**MONTGOMERY COUNTY HISTORIC PRESERVATION COMMISSION**  
**STAFF REPORT**

<b>Address:</b>	7209 MacArthur Blvd., Bethesda	<b>Meeting Date:</b>	12/7/2022
<b>Resource:</b>	Contributing Resource <b>Potomac Overlook Historic District</b>	<b>Report Date:</b>	11/30/2022
<b>Applicant:</b>	Kim & Arthur Newmyer (Robert Black, Architect)	<b>Public Notice:</b>	11/23/2022
<b>Review:</b>	HAWP	<b>Staff:</b>	Dan Bruechert
<b>Permit No.:</b>	1008960	<b>Tax Credit:</b>	Partial
<b>Proposal:</b>	Partial demolition and construction of a new rear addition, hardscape alteration, and fenestration alterations.

## Response to Historic Preservation Commission Preliminary Consultation Report

Re: 7209 MacArthur Blvd, Bethesda, MD

2 SOUTH EAST ELEVATION - PROPOSED  
A201 1/4"=1'-0"

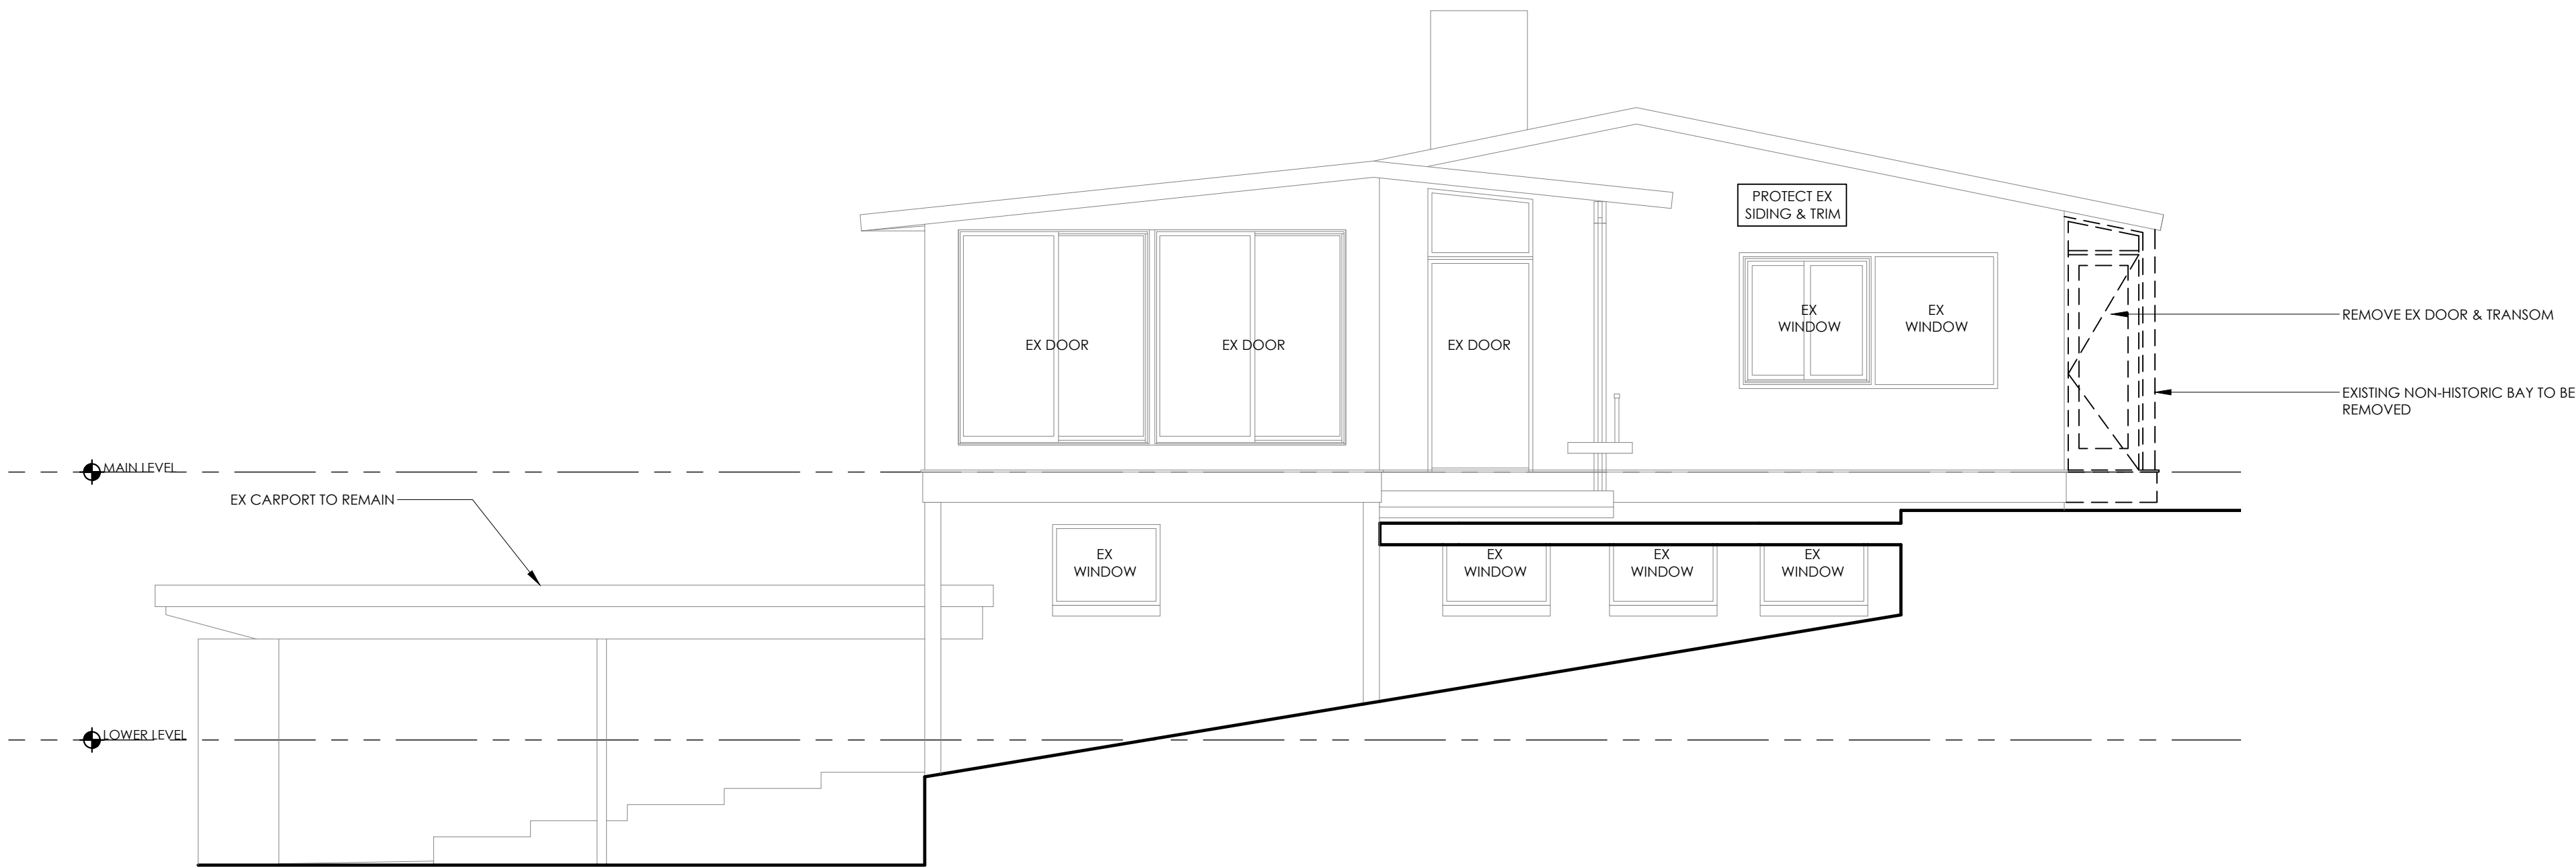
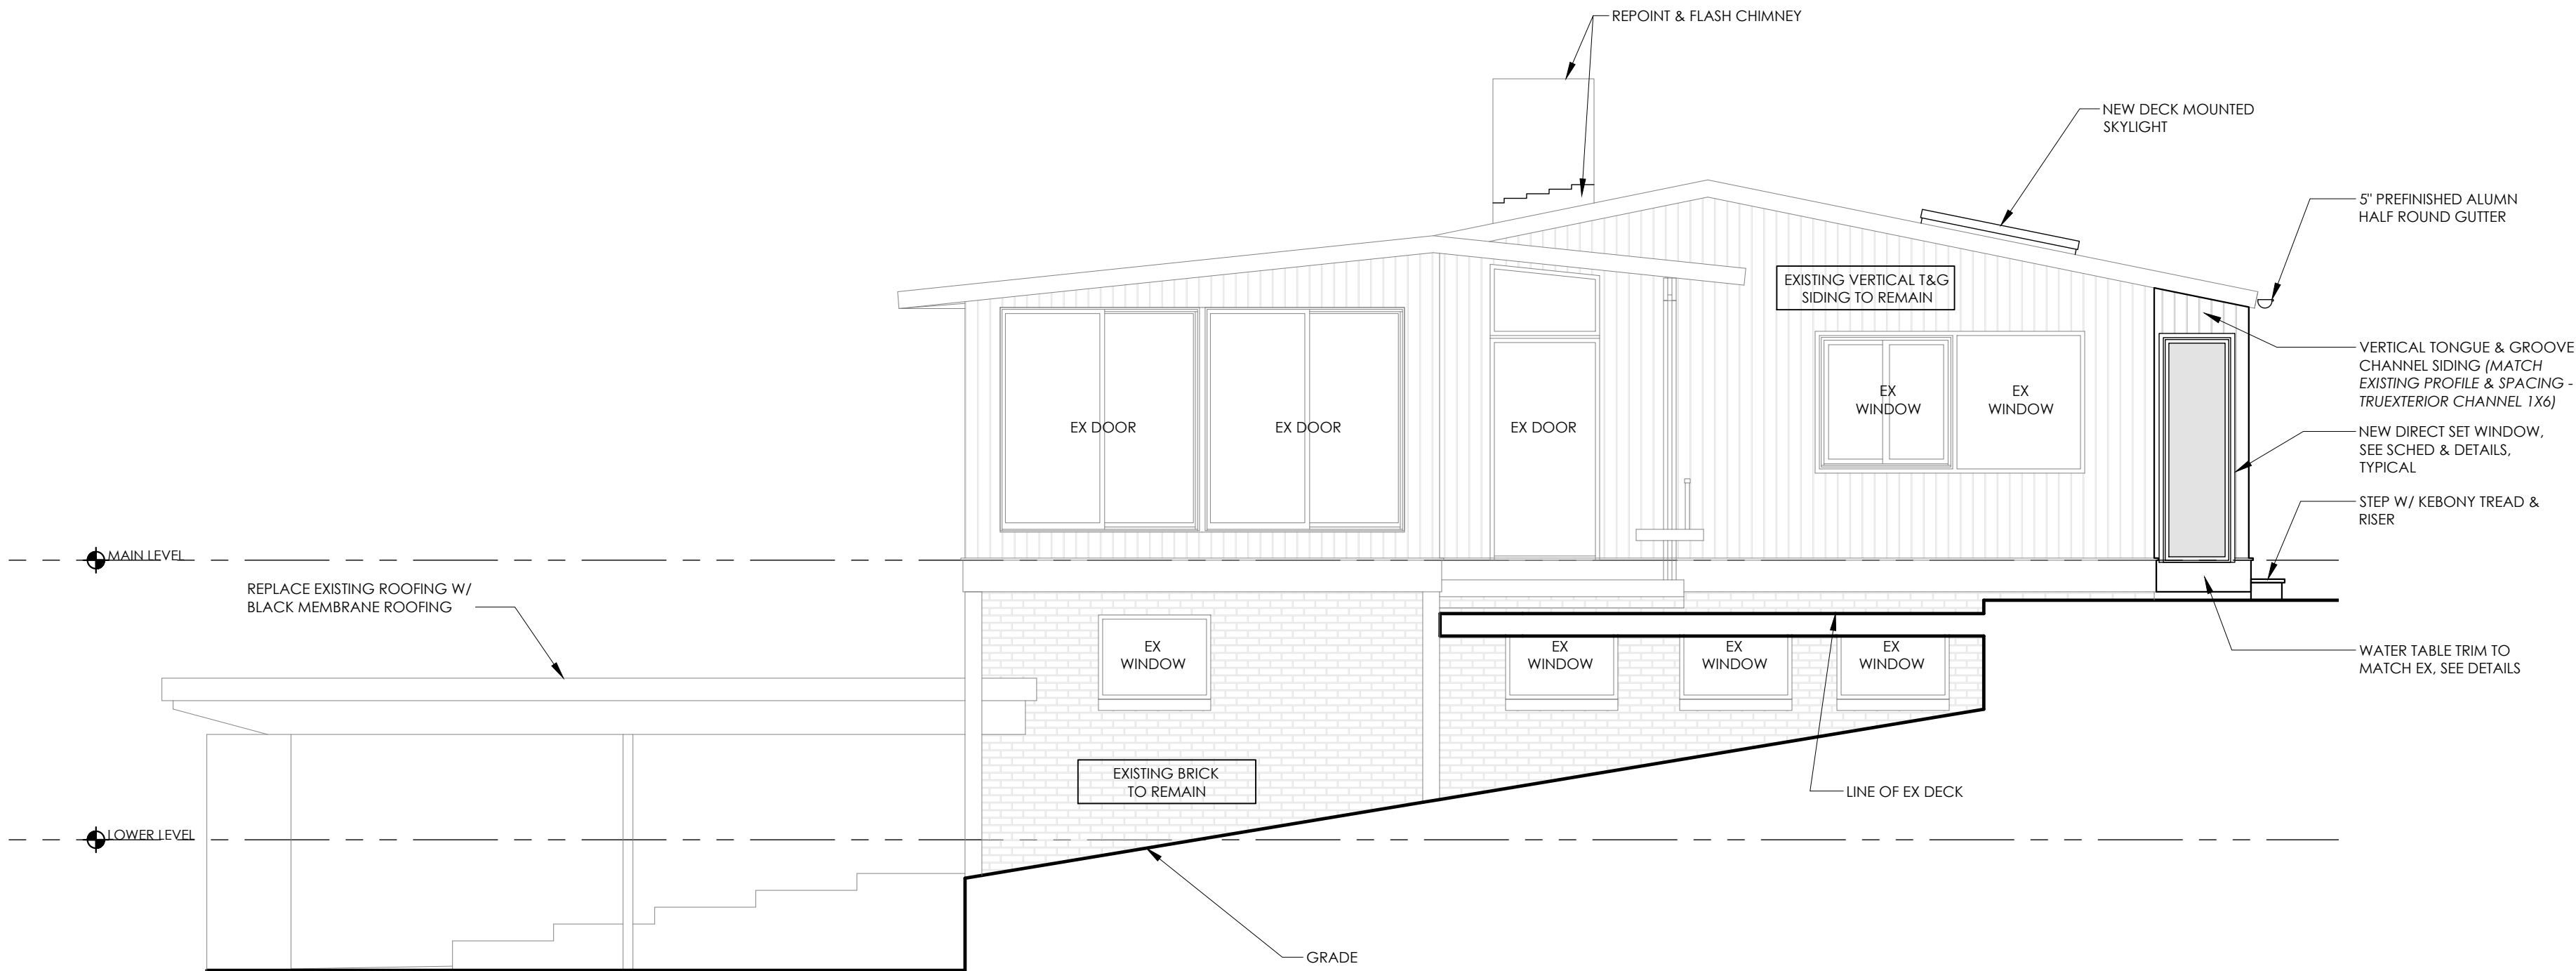
- **Comment:** *There was discussion between the Commissioners where several found that the rear fenestration was acceptable, and others supported replicating the existing fenestration on the rear addition. Staff recommends replicating the existing fenestration pattern.*

**Response:** The proposed rear fenestration pattern has been revised to replicate the existing pattern (See drawings A200, A201, A203, A300). The proposed windows are Marvin Ultimate aluminum clad wood framed awning windows (A800 shows section details of units proposed). The unit size is similar in width, height and the sills align. Placement is approximate to the existing. The vinyl window to the left of the proposed sliding glass door is being replaced with a Marvin Ultimate aluminum clad glider type unit. The size matches the original historical units.
